# Staff Report

## Historic Review of Exterior Alterations & Adjustment

HI-13-20 & AD-03-20

PROJECT:  
GARAGE CONVERSION

**E1 FRONT ELEVATION**  
SCALE: 1/4" = 1'-0"

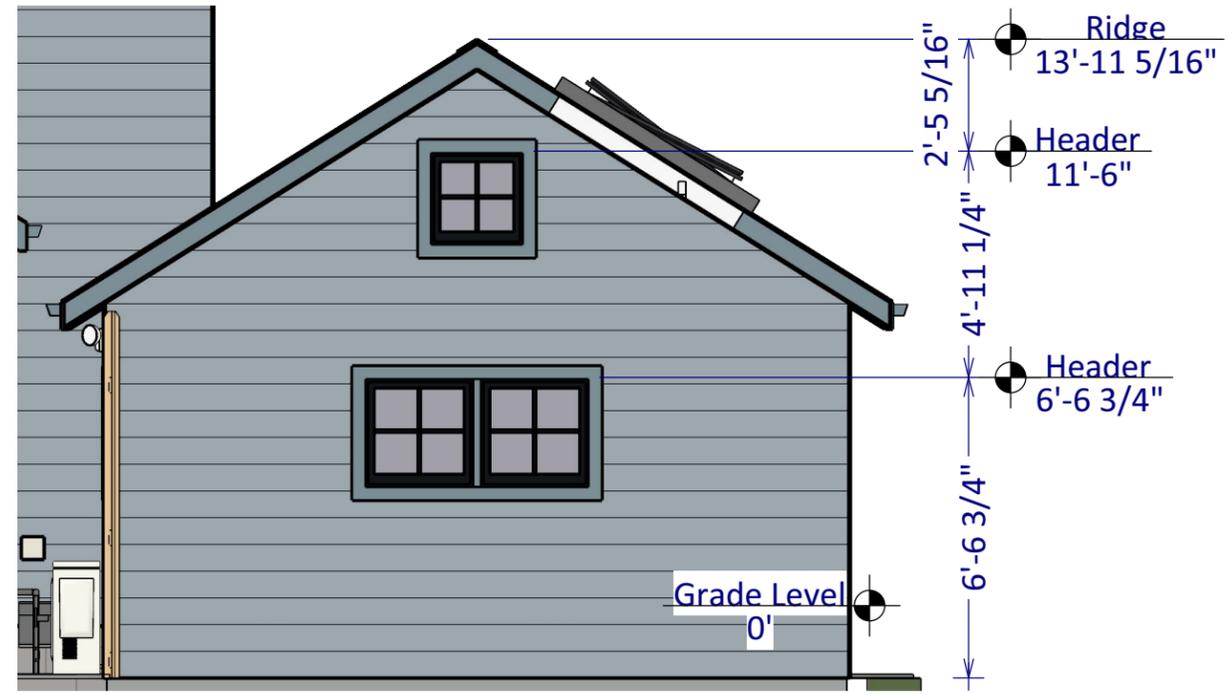
3. On the western elevation (partially visible from the street) the applicant proposes to:
  - a. Replace the existing sliding garage door with a wide throw hinged double door and a solid panel (Attachment C).

- b. The new door will utilize like for like materials to match the appearance of the existing siding and trim (Attachment C).
4. On the southern elevation (not visible from the right-of-way), the applicant proposes to:

FRAME IN 6' DOUBLE DOOR, KEEP TRIM IN SAME LOCATION LOWER HEADER, ADD PANEL TO FILL IN SPACE

1. Only one of the review criteria in ADC 7.120(1) must be met for the proposed alterations to be approved.
2. The proposal is to convert a detached garage into habitable space. The proposed alterations that are visible from the right-of-way will not alter or change the exterior appearance of the structure, meeting the criteria in ADC 7.120(1)(a).
3. All other proposed alterations are not visible from the right-of-way, meeting the criteria in ADC 7.120 (c).
4. This application satisfies the review criteria for a director-level decision based on compliance with ADC 7.120(1)(a) and (c) with conditions.
